# 1963 - 1964 Corvette: Service Bulletin: 3-Speed Transmission Problems

**Source:** Chevrolet Technical Service Bulletin

**Bulletin No:** TSB #1008 DR #676

**Date:** July 16, 1964

FIGURE 2 - MAST JACKET ASSEMBLY

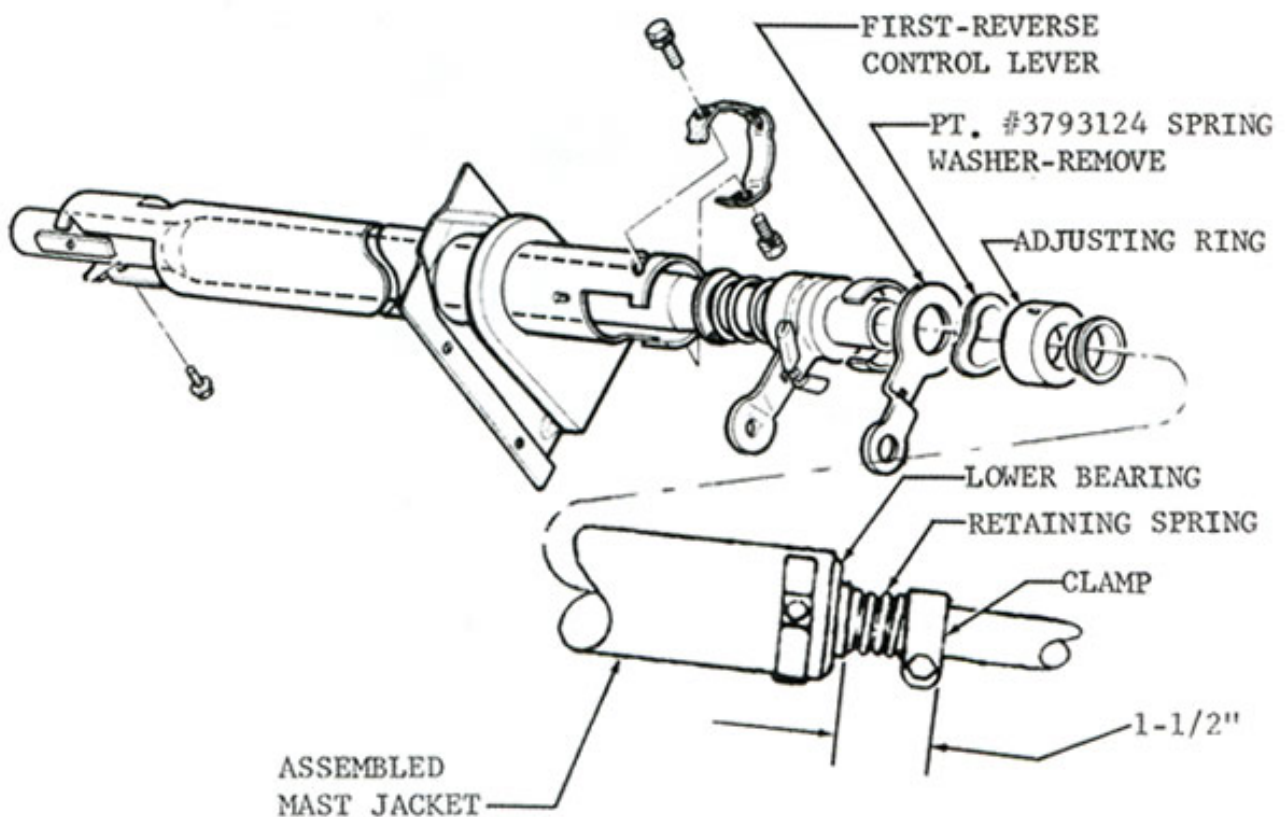
To provide a more positive shift on truck models, Part No. 3793124, transmission control 1st and reverse lever spring washer is being omitted in production and should be removed from units in service. The procedure to remove this spring washer and to readjust lever clearance is as follows:

1. Refer to Figure 2 for parts identification. Place shift lever in neutral; remove access cover from fender skirt.

2. Remove cap screws retaining adjusting ring to mast jacket.
3. Loosen steering shaft lower bearing retaining spring clamp.
4. Slide adjusting ring downward along steering shaft until Part No. 3793124, spring washer, is exposed. Cut and remove spring washer from steering shaft.
5. Apply lubriplate to thrust surfaces of control levers, relay lever and adjusting ring.
6. Position adjusting ring in mast jacket; align holes in ring with slots in mast jacket and install cap screws, but do not tighten.
7. Rotate adjusting ring upward until clearance of .005" exists between first-reverse control lever and ring as shown in Figure 3. Tighten cap screws.

8. Force lower bearing retaining spring clamp upward against spring tension until a dimension of 1-1/2" exists between lower bearing and clamp as shown in Figure 2. Tighten clamp bolt.
9. With transmission side cover selector levers in neutral position, adjust selector rod lengths per instructions in the appropriate shop manual to provide proper neutral cross-over. Replace access cover when adjustments are completed.

FIGURE 4 - INSTALLATION OF THRUST WASHERS IN CHEVY VAN

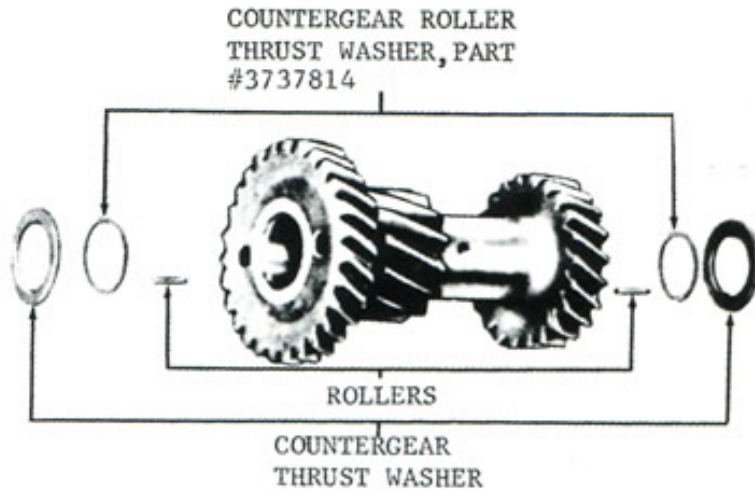
On Chevy Van models with three-speed transmissions, a small steel thrust washer is used between the countergear thrust washer and the countergear roller bearings at each end of the countergear. Since the 1964 Chevy Van Shop Manual is supplemented to the 1963 Truck Shop Manual in this area, reference to this part is omitted in error.

Figure 4 illustrates installed location of this thrust washer in Chevy Van transmissions.

FIGURE 5 - INSTALLATION OF MAGNETIC CHIP COLLECTOR

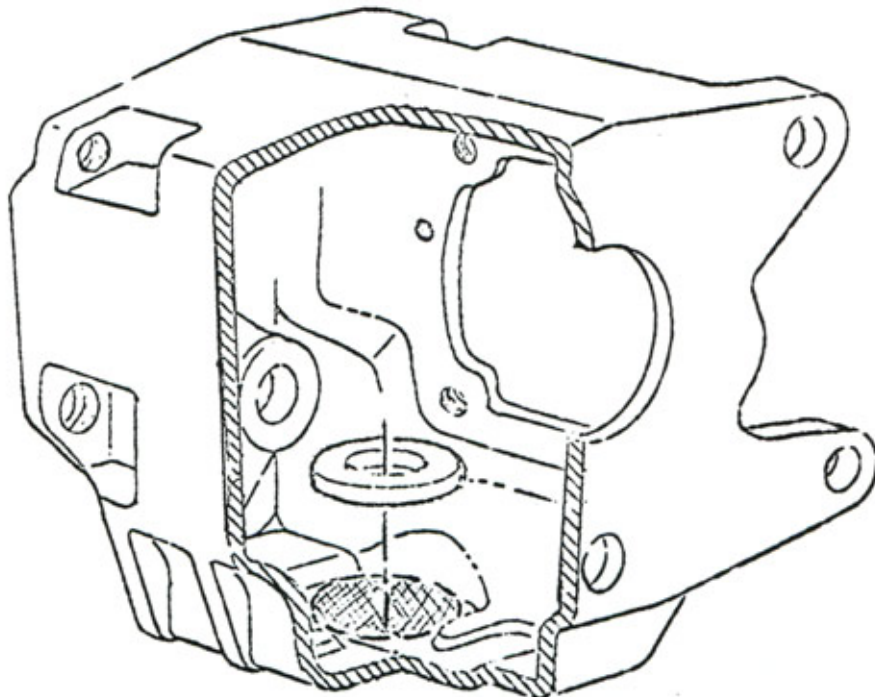
Service Kit #3869240 has been released for field installation of the chip collector on 1963 and 1964 3-speed transmissions built prior to the above dates. The kit includes the magnet, cement, and instruction sheet. It also contains a 3/8 inch high pedal bumper for increasing clutch release on all except Chevy Van (Reference - Gear Clash - First and Reverse Shift). It is recommended that whenever a 1963 or 1964 3-speed transmission is disassembled for any reason, that the magnet be installed using the following procedure.

3. Wipe magnet and area in case where magnet is to be installed with Acetone or Toluol (available at most drugstores). Area where magnet is to be installed must be clean, dry and free from oil and grease film. When Acetone or Toluol is applied, be sure to use in ample quantity to neutralize grease and oil which may be in pores of casting surface. Do not touch cleaned area with hands.

4. Using cement supplied in kit, apply about a 1/16 inch thick film over entire bottom surface of magnet and immediately place in case as shown in sketch. Press straight down - do not twist while pressing in position. Note: If cement from tube appears to be thick, discard thick or hardened chunks and use cement from middle or bottom of tube.

5. To cure cement, place a trouble light with a 100 watt lamp inside of case as close to magnet as possible, and allow to stand for a minimum of 30 minutes. Use care not to touch magnet or knock it out of position. A heat lamp, if available, may be used in place of 100 watt lamp.
